Subject: Crazy Horse Switching Station – Approval of Minor Project Modifications #1-4

**To:** Andrew Barnsdale, CPUC  
**From:** Jeff Smith  
**Date:** August 16, 2012  
**Subject:** Crazy Horse – Analysis of PG&E Minor Project Modifications #1-4

**Re: Crazy Horse Canyon Switching Station Project – Minor Project Modifications**

Figure 1: Proposed Project Workspace Modifications

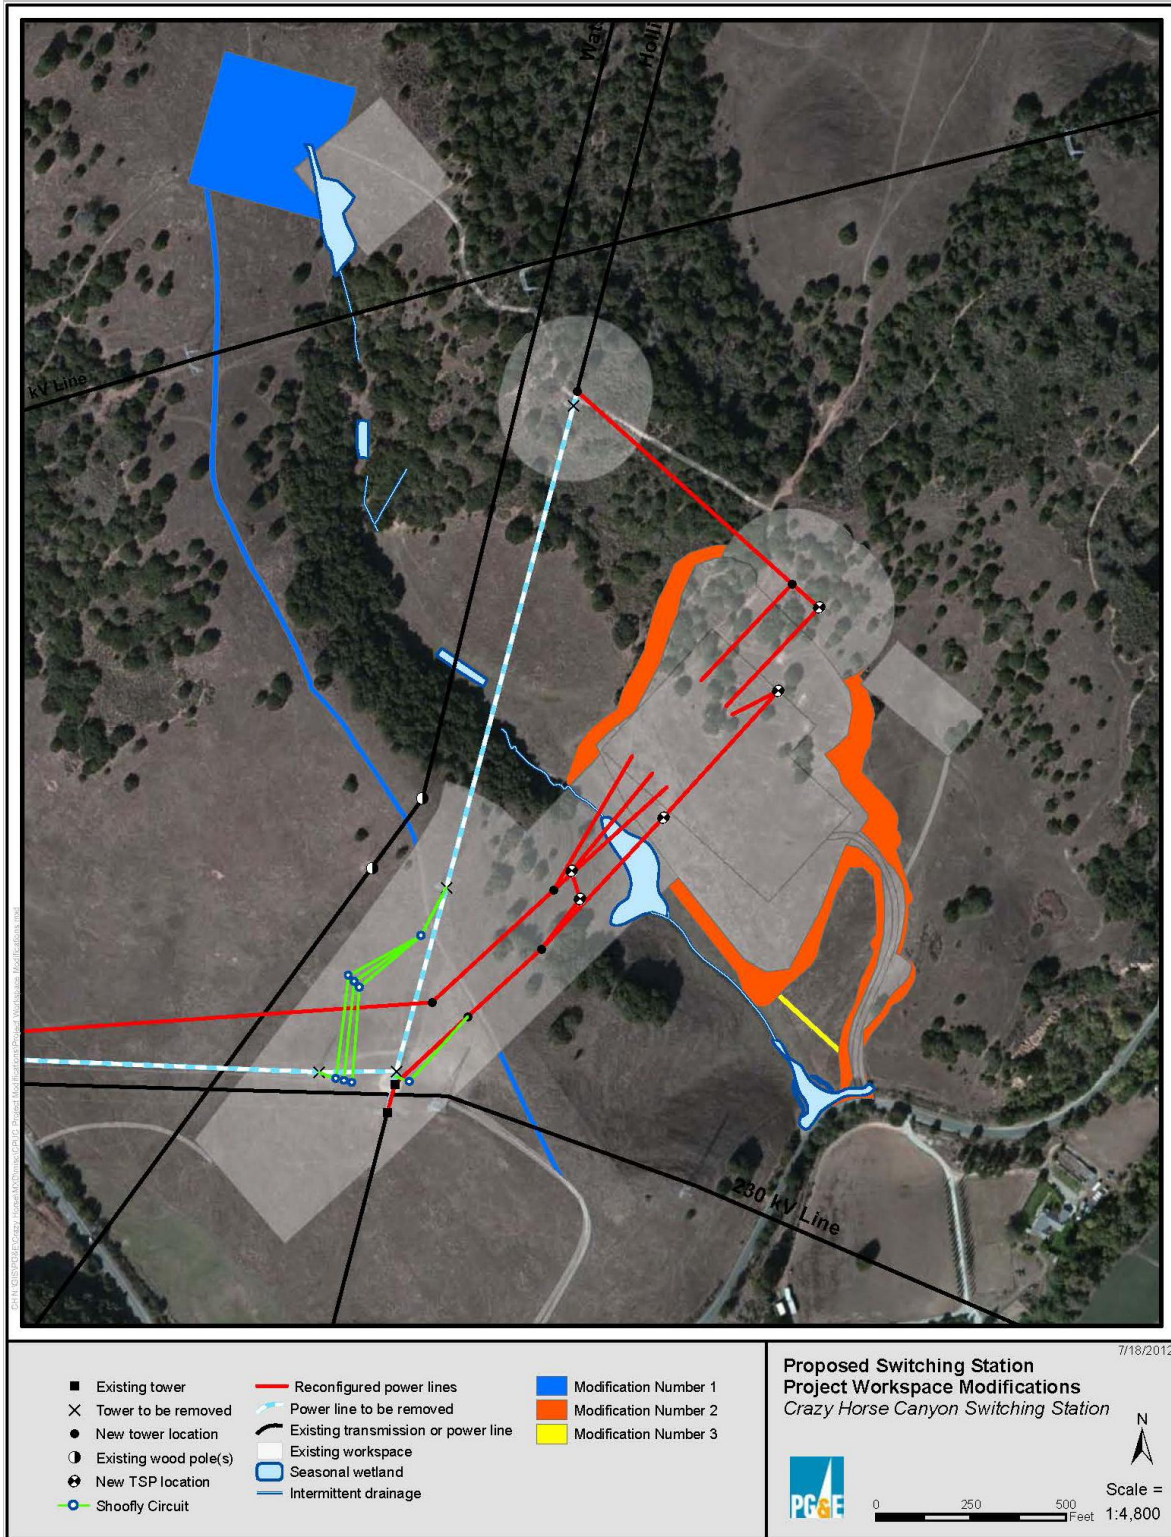
*The originally-proposed helicopter landing zone for the Crazy Horse Project was located at a proposed 2-acre site northwest of Tower 0/4 and the 500 kV transmission line, and accessed by*

*an existing dirt road from Tower 0/4. PG&E now proposes to use the helicopter landing zone that is part of the approved PG&E Hollister 115 KV Reconductoring Project. This helicopter landing zone is located northwest of the landing zone proposed in the Crazy Horse Canyon Switching Station Project PEA, and the two areas overlap. The use of landing site was addressed in the Hollister project IS/MND (CPUC 2011).*

*Additionally, PG&E proposes to use the temporary access road currently being used for the Hollister Project. This existing, two-track unpaved road extends from the Lagunitas Switch area north to the Hollister helicopter landing zone. The temporary access road would be used to access the helicopter landing zone, Tower 0/4, and the northern end of the switching station site.*

*Use of the Hollister helicopter landing zone and associated access road would increase the Crazy Horse project workspace by 0.75 acre as the Hollister landing site is slightly larger. Use of the Hollister access road would increase the temporary workspace of the Crazy Horse project by 0.80 acre. The total change in workspace area for this modification would be a net increase of 1.55 acres of temporary workspace. No additional grading of the road would be required as the road has already been graded and is in use for the Hollister project.*

*The April 2010 project PEA described the temporary and permanent workspaces during preliminary engineering design. The workspaces were delineated generally based on a specific number of feet in all directions. The final engineering design has now been completed and requires modifications to the workspace area. The modification would result in a net increase in acreage for both temporary and permanent ground disturbance. The changes to the workspace areas are shown in Figure 1.*

*A portion of this proposed logging truck route was not included in the Final IS/MND. The proposed new segment of temporary access road is located within the project study area that was analyzed in Final IS/MND and is shown on Figure 1. This segment of new temporary roadway would be approximately 215 feet long and 16 feet wide, and would stretch from the southern point of the approved switching station workspace area to the approved permanent access roadway workspace area. The new segment of temporary access road would increase the acreage of temporary workspace by 0.079 acres, which has been included in the additional temporary workspace acreage totals in Minor Project Modification #2. The new segment of temporary access roadway would require improvement through blading, and would be restored through hydroseeding after completion of tree removal activities.*

Figure 2: Proposed Tree Removal Modifications

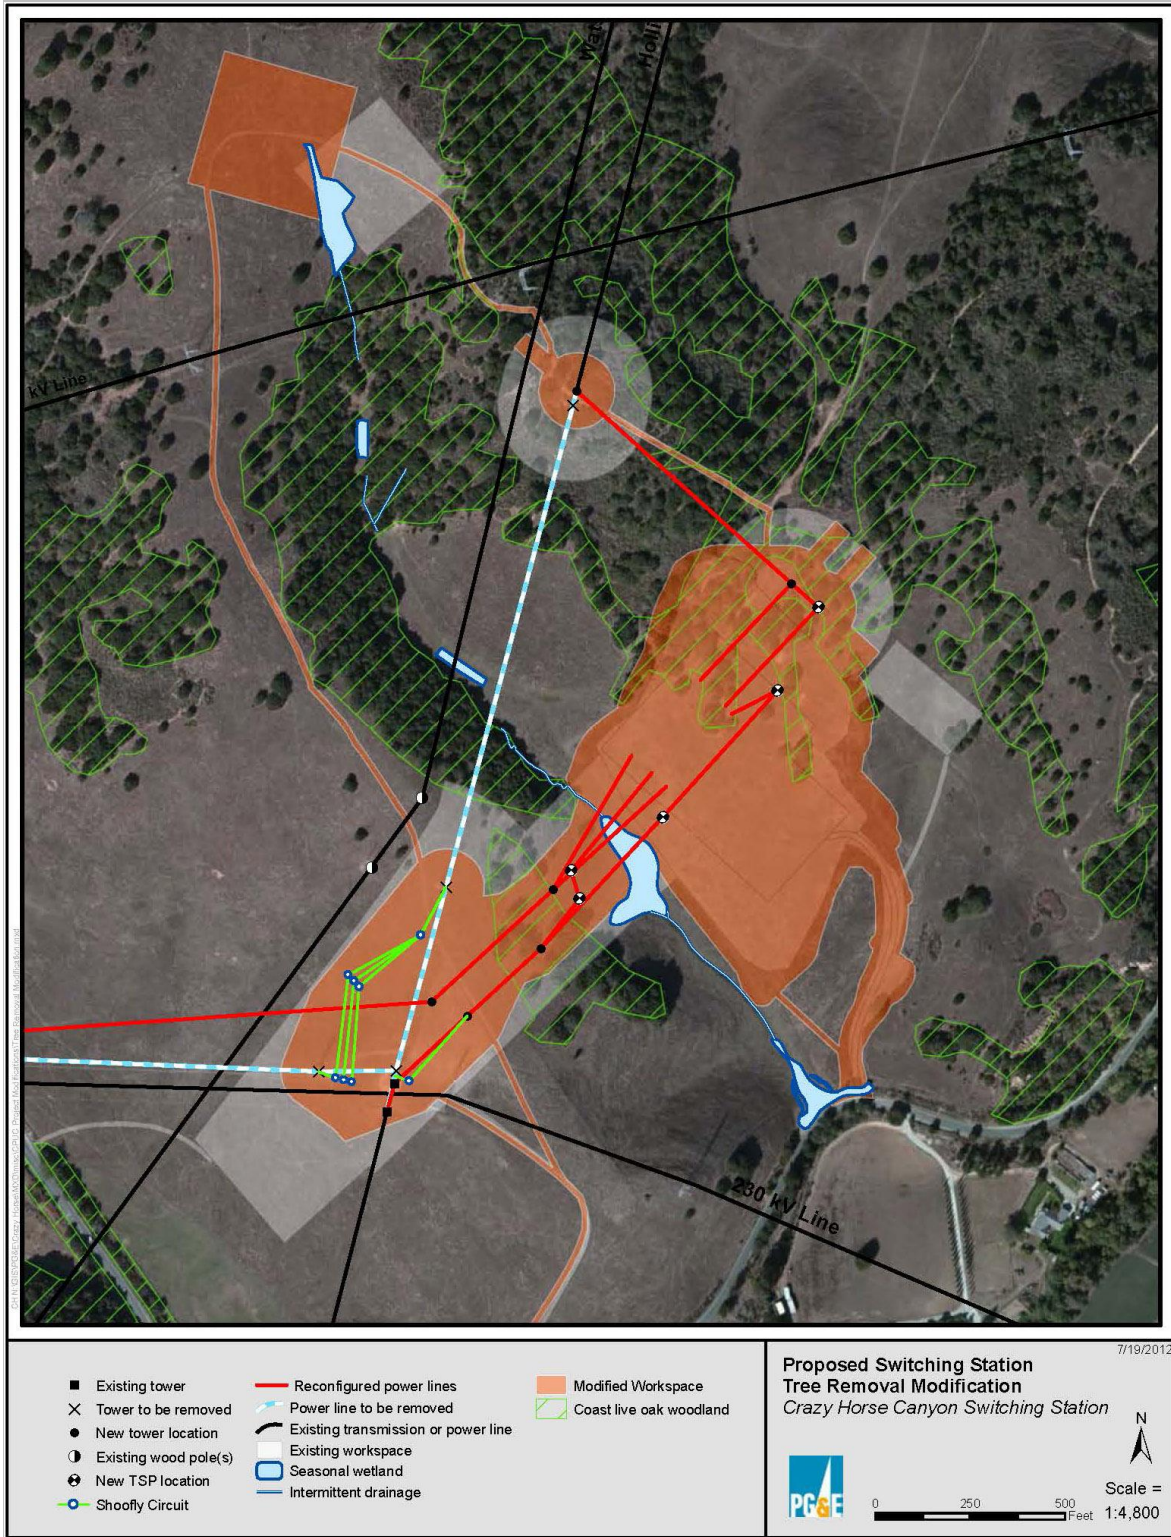
*Following the December 2011 oak tree survey, it was determined that additional permanent and temporary workspace areas would be required for the project (as described under Minor Project Modification #2). Figure 1 shows the expanded workspace areas and Figure 2 shows where the expanded workspace areas overlap with existing oak woodland.*

*A second oak tree survey was performed on May 25, 2012 to analyze the expanded workspace areas. It was determined that an additional 0.46 acre of oak woodland would need to be removed to accommodate the expanded workspace areas, increasing the total acreage of oak woodlands to be removed to 6.71 acres. The additional 0.46 acre would involve the removal of 76 additional trees, including 24 coast live oak*

trees, as part of the workspace expansion around the switching station facility, and 52 oak trees to accommodate the expanded temporary workspace areas for the new towers and poles. None of these 76 additional trees would qualify as Landmark Trees under Monterey County regulations. The revised tree removal counts would include 122 oak trees for the construction of the switching station facility, 5 oak trees for the construction of the new access road, and 75 oak trees for the new towers and poles. Table 3 provides a comparison of the acreage of oak woodland and the number of trees approved for removal in the Final IS/MND and the additional oak woodland and trees that would be removed for the expanded workspace areas.

PG&E has identified up to 1.23 acres of oak woodland that could potentially be saved from removal. It is unknown at this time if all or a portion of these 1.23 acres can be spared from removal, and the analysis below therefore assumes that none of the 1.23 acres can be spared, and that the net change would be an increase of 0.46 acres of oak woodland to be removed, for a new total of 6.71 acres of oak woodland removed from the site.

- **Condition of Approval #1:** PG&E shall remove no more than 6.25 acres of oak woodland from the project site. PG&E shall reduce the amount of temporary work area (already approved) by 0.46 acre of oak woodland to offset the additional oak woodland to be removed for the Minor Project Modifications. The area to be omitted from temporary workspace should be shown on a map provided to the CPUC prior to initiation of the Minor Project Modifications.

**Proposed Switching Station  
Project Workspace Modifications**  
*Crazy Horse Canyon Switching Station*

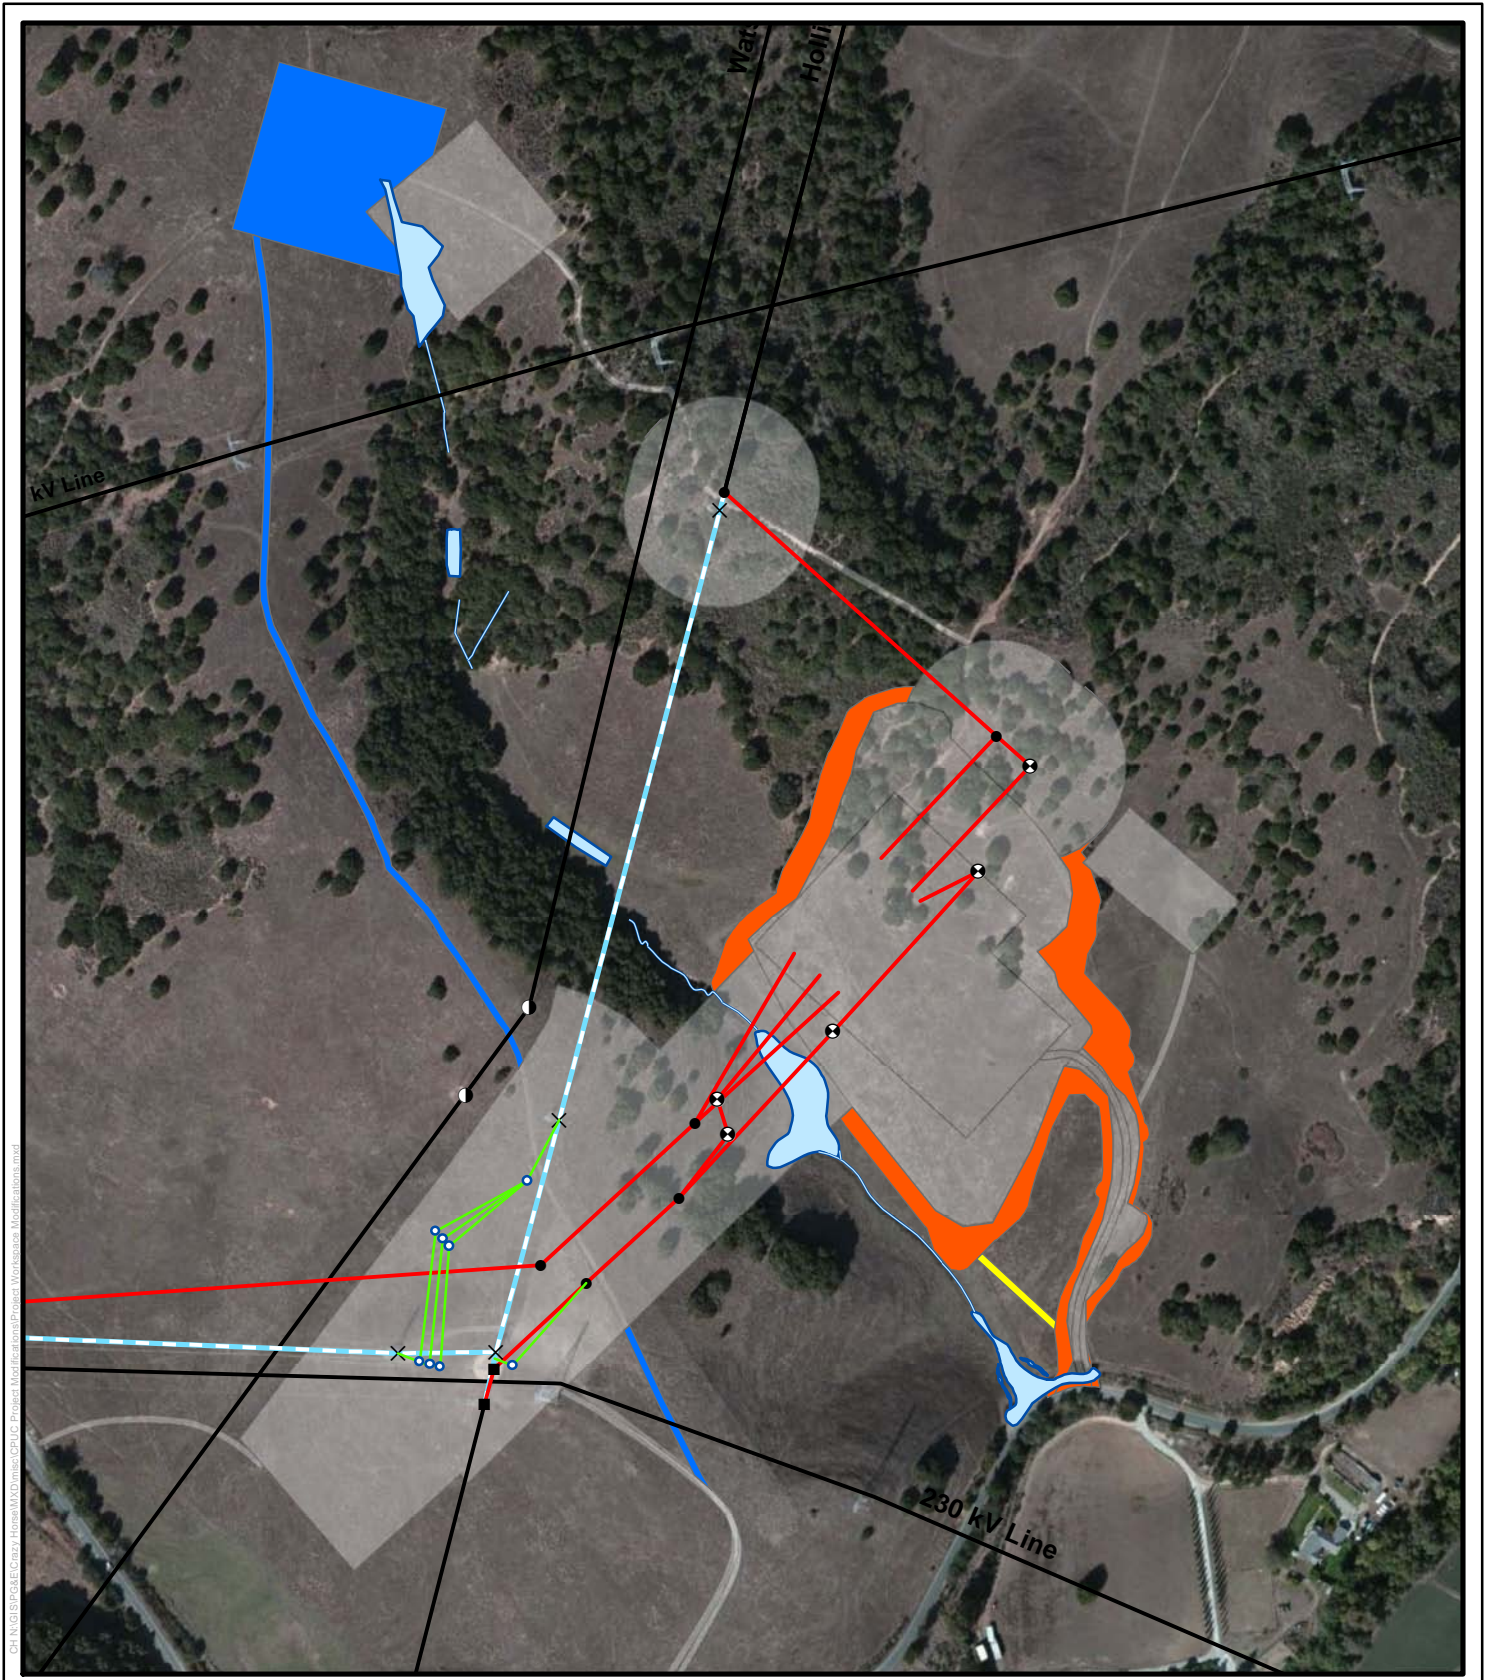
See Modification Number 1 on the attached map.

The permanent area of disturbance will be increased by 0.4 acre at the switching station, and will be decreased by 0.2 acre along the new permanent access road, resulting in a total increase in area of 0.2 acre. The 3.4-acre increase in temporary workspace is due minor inconsistencies between the workspace as depicted in Figure 1-2b and the CAD data for the engineering design, and the addition of a width of 16 to 30 feet of workspace around the edge of the cut and fill that is needed for the equipment to install the drainage system around the outside of the benched cut and fill slope as well as travel around the switching station cut and fill area once the benches have been created.

In early 2012, through consultation with key project personnel, the temporary workspace configuration was revised and finalized during a June 6, 2012 site visit. While it was determined that an additional 3.4 acres of temporary workspace is required in order to complete construction of the switching station, an effort was also undertaken to identify areas of temporary workspace that may not be needed. Through this process, it was identified that approximately 10.8 acres of approved temporary workspace may not be required and will not be disturbed unless needed. Burrow excavation and tree clearing will not initially be performed in these areas which consist of the two pull sites and portions of workspaces around towers and poles. Therefore a net decrease in the overall temporary impact area of the project is anticipated.

See Modification Number 2 on the attached map.

The project PEA, dated April 2010, described the proposed access areas, including access to the switching station and power line reconfiguration work areas via San Juan Grade Road and Crazy Horse Canyon Road, and the proposed construction of a permanent access road from San Juan Grade Road to the switching station. Prior to construction, approximately 200 trees need to be removed from the workspaces. Tree removal is planned to occur in September 2012. The new permanent access road described in the PEA will not yet be constructed, and the logging trucks when full, need to drive in a downhill direction.

To remove the trees from the cut and fill area of the switching station work area, the logging trucks will access the workspace from the northern end, and collect logs as they drive downslope along the existing two-track that is within, and parallels the northwest side of the workspace. At the bottom of the slope, the trucks will proceed through the existing gate in the fence line, and then drive along the south/west side of the fence, within the existing workspace. At the southern tip of the cut and fill workspace, a new strip of temporary workspace will be required for the trucks to reach the permanent access road near where it connects to San Juan Grade Road (see the attached figure). This new temporary workspace will be 215 feet long and 16 feet wide, and will add a total of 0.79 acre of workspace to the project's temporary footprint. The entire length of this temporary access road for the logging truck (both within the existing temporary workspace adjacent to the fence line and the additional 215 feet of connecting workspace) will be bladed prior to the trucks using it. PG&E anticipates the logging operation will require approximately 10 trucks per day for approximately three weeks in September. Once tree removal is complete, this new temporary access road will be restored by hydroseeding.

See Modification Number 3 on the attached map.
